Access Compliance Report

Public Rights-of-Way

Intersection ID: 47696	Main Street: LEES_COURT_ST	Cross Street: WHITBY_LN	Location:	N
ADA ID: AA4BC56E213E	Ramp Type: PerpDiag	Initial Pass/Fail: Fail	Overall Compliance: No	Severity Score: 37.5

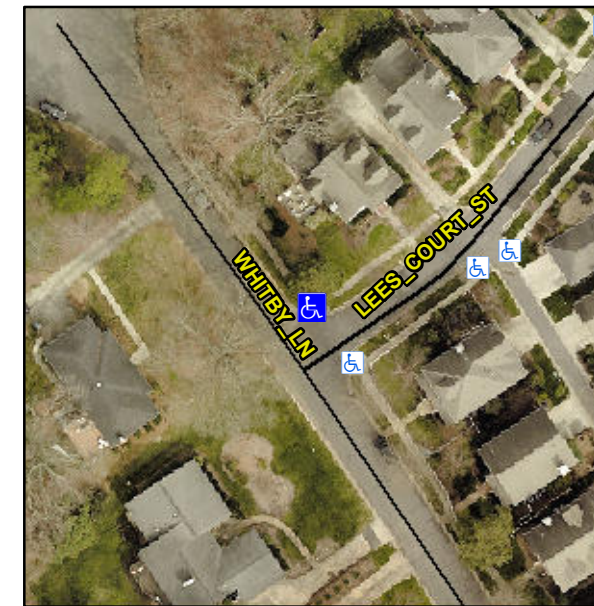
Not Found, R304.2.2, R304.5.3

Compliance	Description	Data	Compliance	Description	Data
N/A	Ramp Length (in)	55.5	No	Ramp Slope (%)	9.3
Yes	Ramp Width (in)	48.0	No	Ramp XSlope (%)	7.8
N/A	Flare Type LT	N/A	N/A	Flare Type RT	N/A
N/A	Flare Slope LT (%)	N/A	N/A	Flare Slope RT (%)	N/A
N/A	Flare Traversable LT?	N/A	N/A	Flare Traversable RT?	N/A
N/A	Landing Length (in)	N/A	N/A	DWS Provided?	N/A
N/A	Landing Width (in)	N/A	N/A	DWS Contrast?	N/A
N/A	Landing Slope (%)	N/A	N/A	DWS Length (in)	N/A
N/A	Landing X Slope (%)	N/A	N/A	DWS Full Width?	N/A
N/A	Landing Curb? (Y/N)	N/A	N/A	DWS Offset (in)	N/A
N/A	Shared Landing?	N/A			
N/A	Gutter Ponding?	N/A	N/A	Gutter Slope (%)	N/A
N/A	Gutter Lip Ht (in)	1.0	N/A	Gutter X Slope (%)	N/A
N/A	Painted X Walk1?	No	N/A	Painted X Walk2?	No
	X Walk 1 Direction	To W		X Walk 2 Direction	To SE
N/A	X Walk 1 Width (in)	N/A	N/A	X Walk 2 Width (in)	N/A
	X Walk 1 Slope (%)	4.7		X Walk 2 Slope (%)	0.0
	X Walk 1 X Slope (%)	1.1		X Walk 2 X Slope (%)	6.0

Remove & Replace Curb Ramp With Two New Directional Ramps or Equivalent.
